Re: CDS22000078 pre-connection enquiry - Subject to contract | Contract denied

Connection for Multi/Mixed Use Development of 377 apartment unit(s), Creche and retail unit at Blakes, The Hill, Dublin

**Re: Design Submission for Blakes, The Hill, Dublin (the “Development”)
(the “Design Submission”) / Connection Reference No: CDS22000078**

TITLE
**PROPOSED FOUL WATER DRAINAGE LAYOUT
GA PLAN**

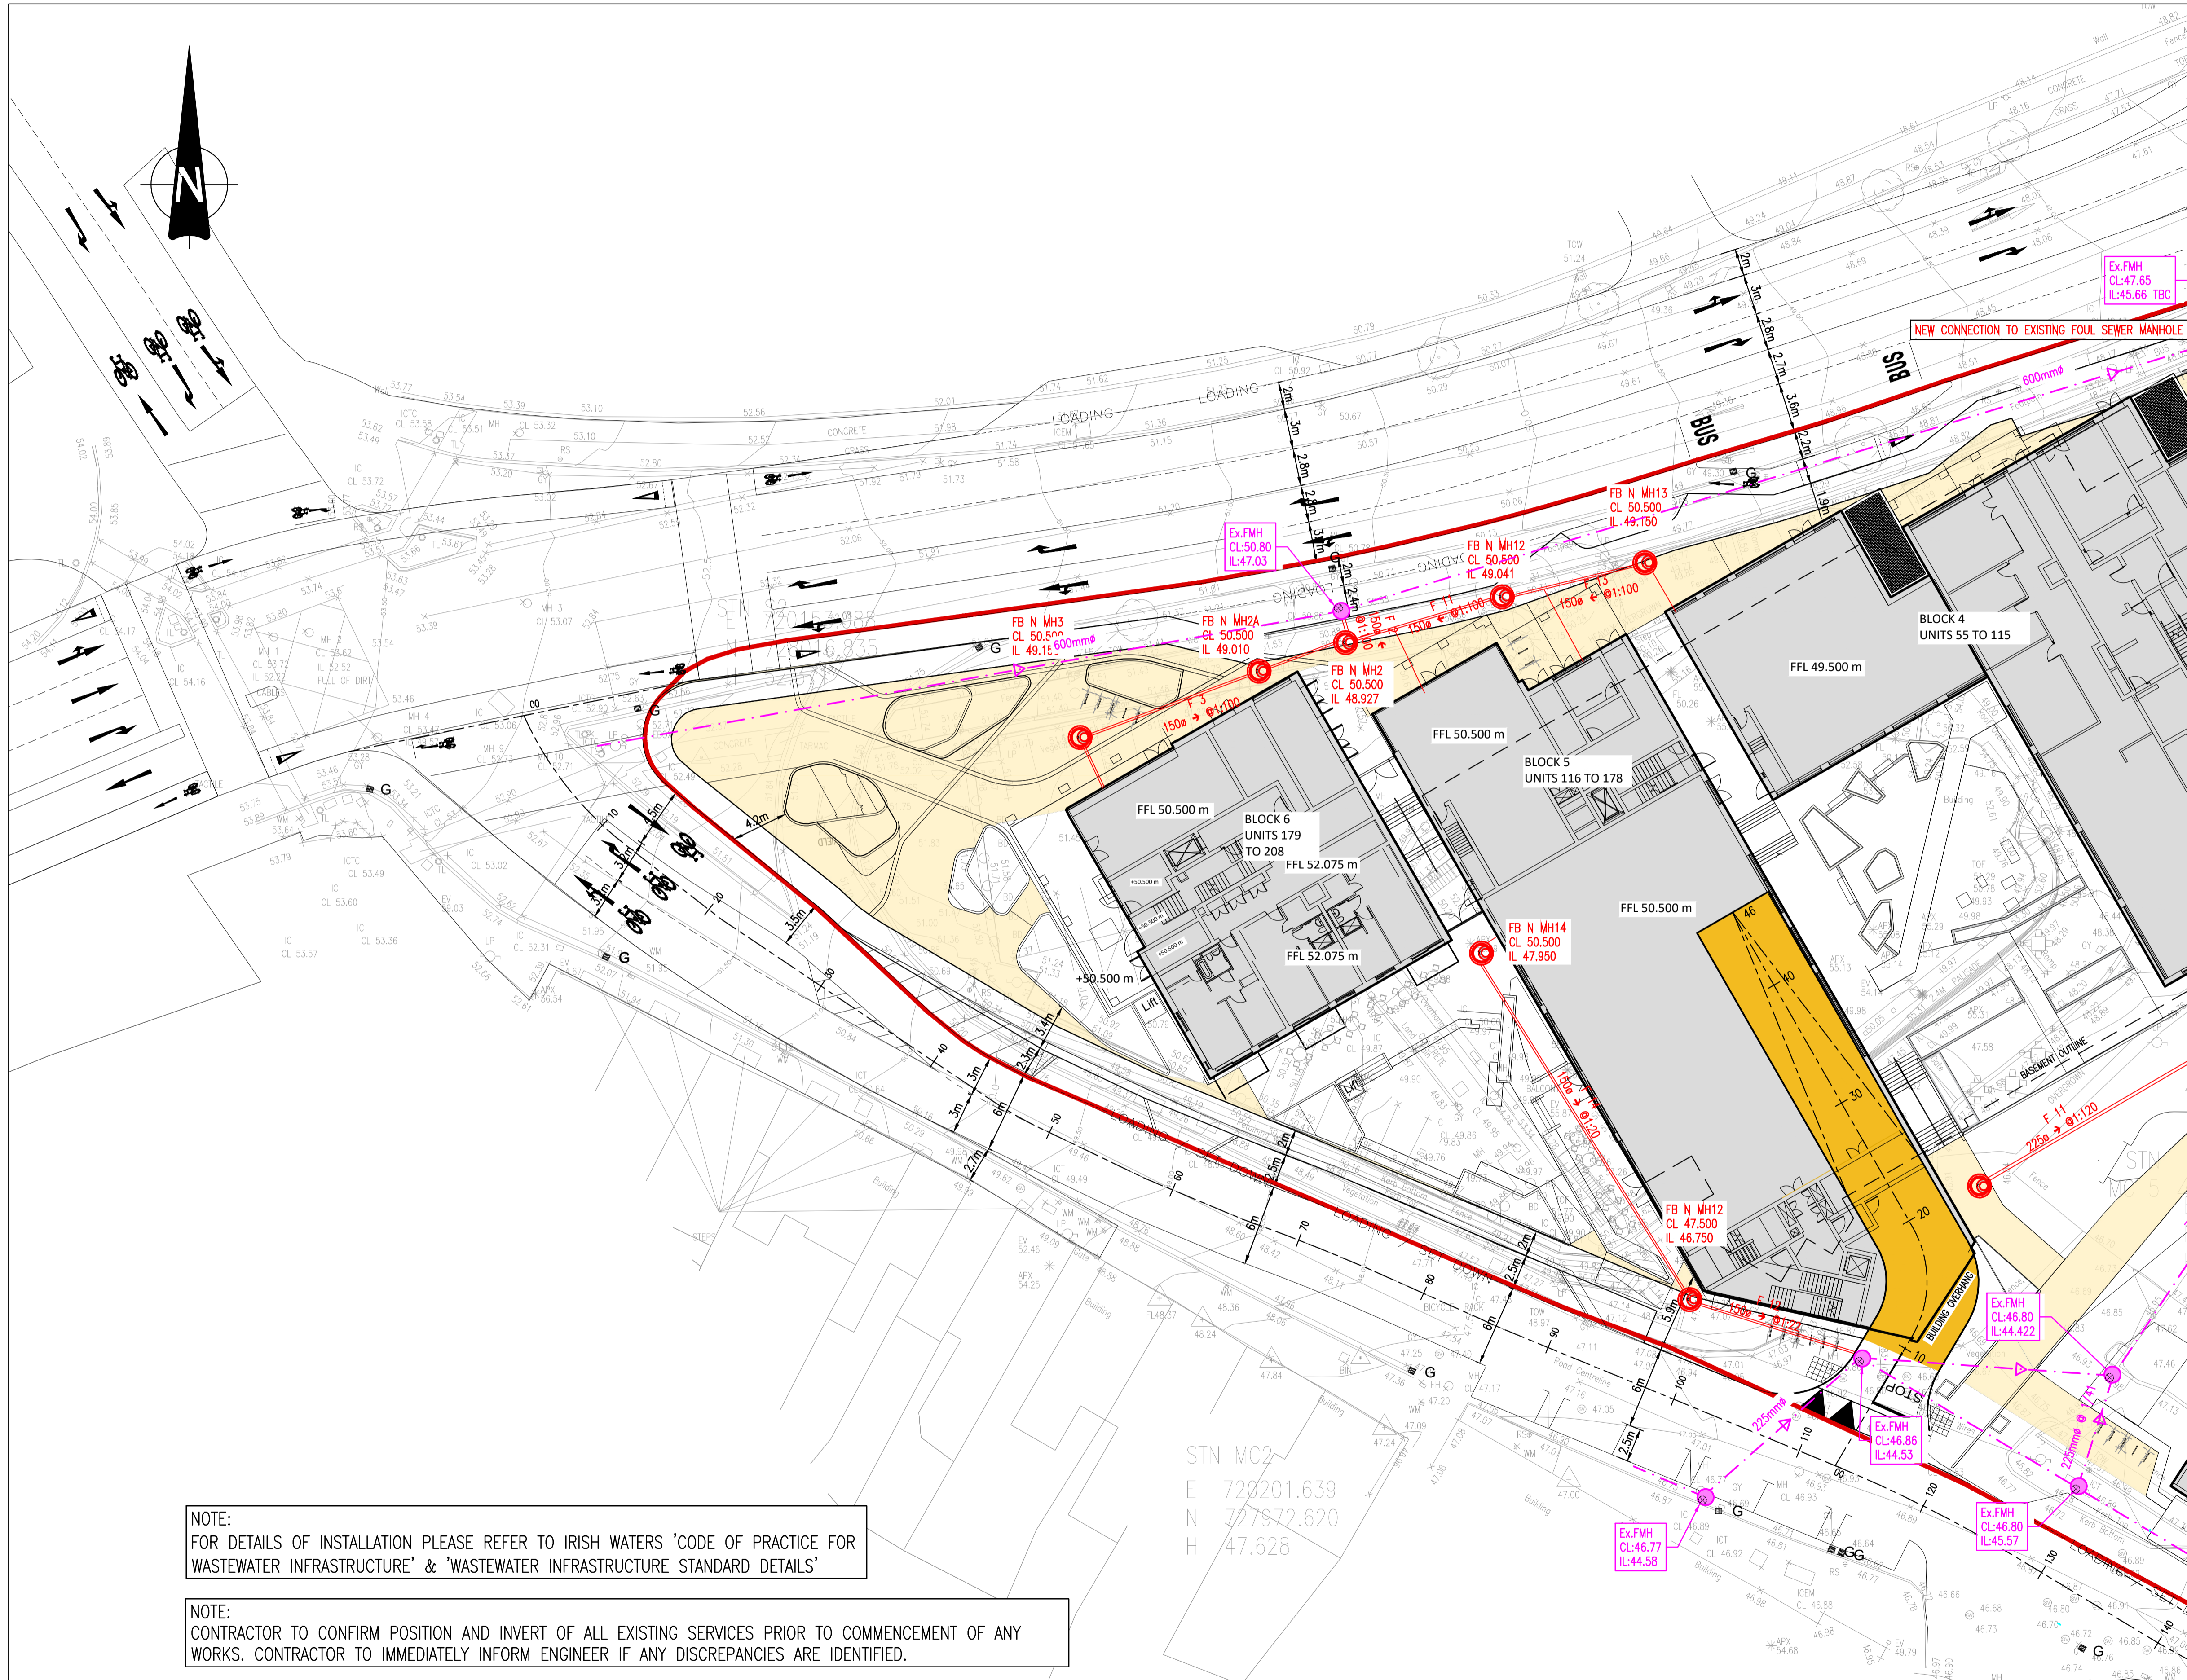
- The design submission will be subject to further technical review at connection application stage.
- Diversion agreement required via <https://www.water.ie/connections/developer-services/diversion-and-build-over/> (details previously agreed with Irish Water and were deemed feasible).
